UNITED STATES PATENT AND TRADEMARK OFFICE

APPLICATION NO.	FILING DATE	FIRST NAMED INVENTOR	ATTORNEY DOCKET NO.	CONFIRMATION NO.
10/811,569	03/29/2004	William J. Pulte	1297A-115	1378
25215 7590 12/20/2006 DOBRUSIN & THENNISCH PC 29 W LAWRENCE ST SUITE 210 PONTIAC, MI 48326			EXAMINER FIGUEROA, ADRIANA	
			ART UNIT 3637	PAPER NUMBER
SHORTENED STATUTORY PERIOD OF RESPONSE			MAIL DATE	
3 MONTHS			12/20/2006	
			DELIVERY MODE	
			PAPER

Office Action Summary	Application No.	Applicant(s)	
	10/811,569	PULTE, WILLIAM J.	
	Examiner	Art Unit	
	Adriana Figueroa	3637

DETAILED ACTION

Fig. 1.

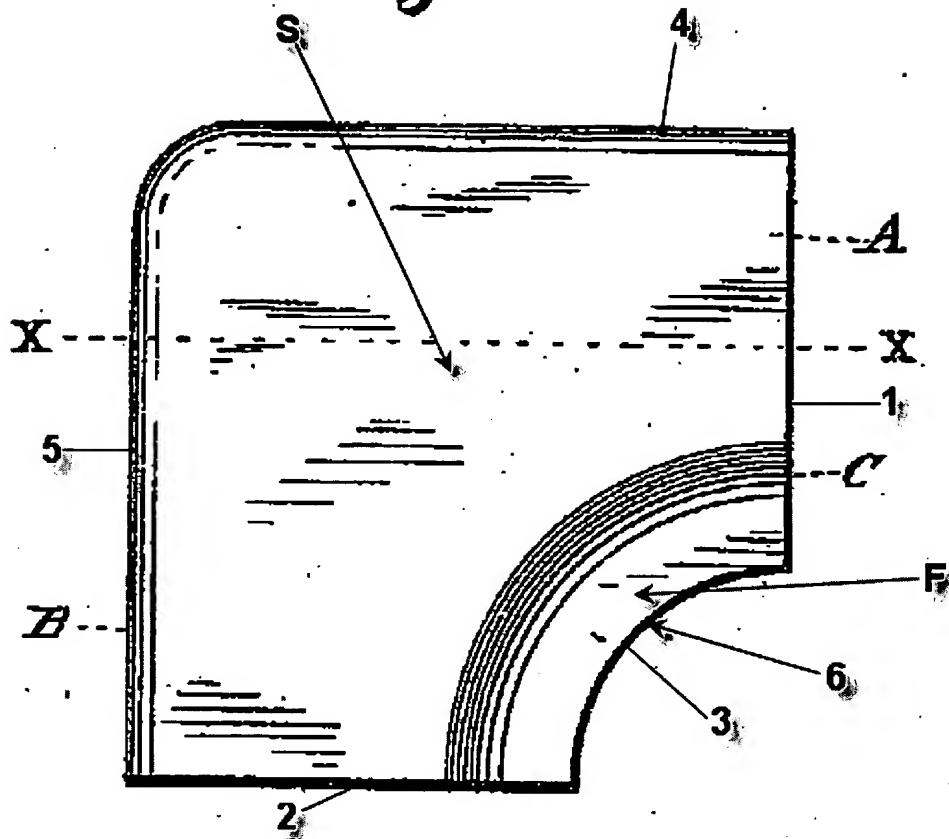
Regarding claim 1, Baker discloses a cap comprising a first surface (F); a second surface (S); and at least one stepped arcuate surface (c) intersecting said first surface and said second surface, (annotated Figure 1).

Regarding claim 3, Baker discloses a cap having a first edge (1) of said first surface, said second surface, and said at least one stepped arcuate surface; a second edge (2) of said first surface, said second surface, and said at least one stepped arcuate surface; a third edge (3) of said first surface; an arcuate surface (6) that intersects vertically with said third edge of said first surface; a fourth edge (4) of said second surface; and a fifth edge (5) of said second surface, (annotated Figure 1).

Regarding claim 11, Baker discloses a cap comprising a first surface (F); a second surface (S); and at least one stepped arcuate surface (c) intersecting said first surface and said second surface; a first edge (1) of said first surface, said second surface, and said at least one stepped arcuate surface; a second edge (2) of said first surface, said second surface, and said at least one stepped arcuate surface; a third edge (3) of said first surface; an arcuate surface (6) that intersects vertically with said third edge of said first surface; a fourth edge (4) of said second surface; and a fifth edge (5) of said second surface, (annotated Figure 1).

Fig. 3.

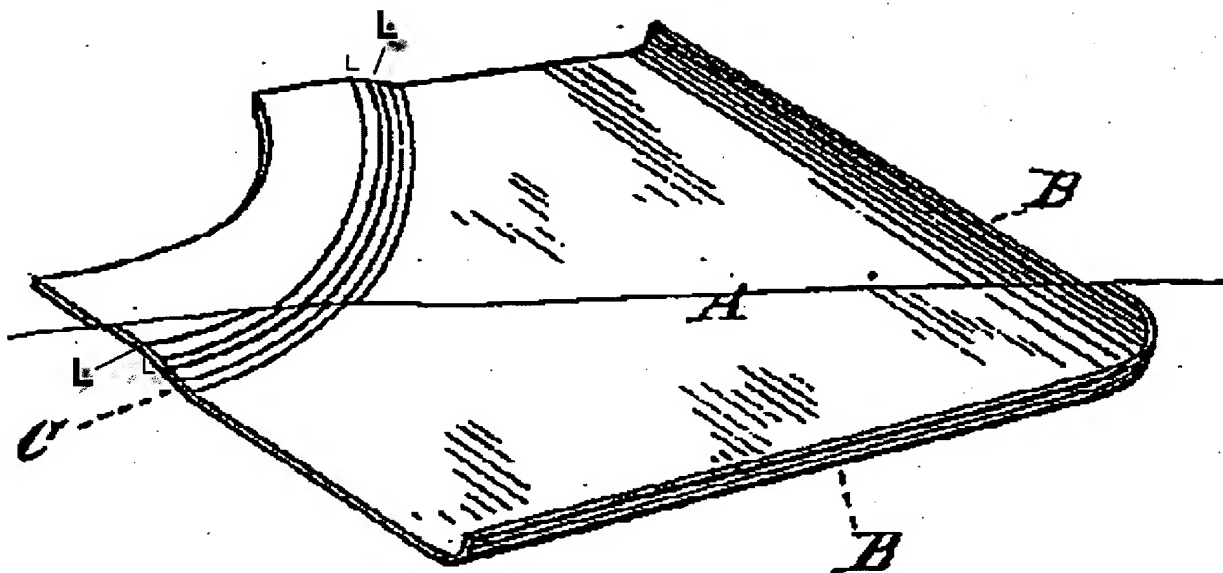
Regarding claim 2, Baker discloses a cap wherein said at least one stepped arcuate surface (c) consists of an "L" cross sections, (Figure 1, annotated Figure 3).

Regarding claim 8, Baker discloses a cap wherein said plurality of stepped arcuate surfaces (c) consists of "L" cross sections, (Figure 1, annotated Figure 3).

Regarding claim 12, Baker discloses a cap wherein said at least one stepped arcuate surface (c) consists of an "L" cross sections, (Figure 1, annotated Figure 3).

Regarding claim 17, Baker discloses a cap wherein said plurality of stepped arcuate surfaces (c) consists of “L” cross sections, (Figures 1, annotated Figure 3).
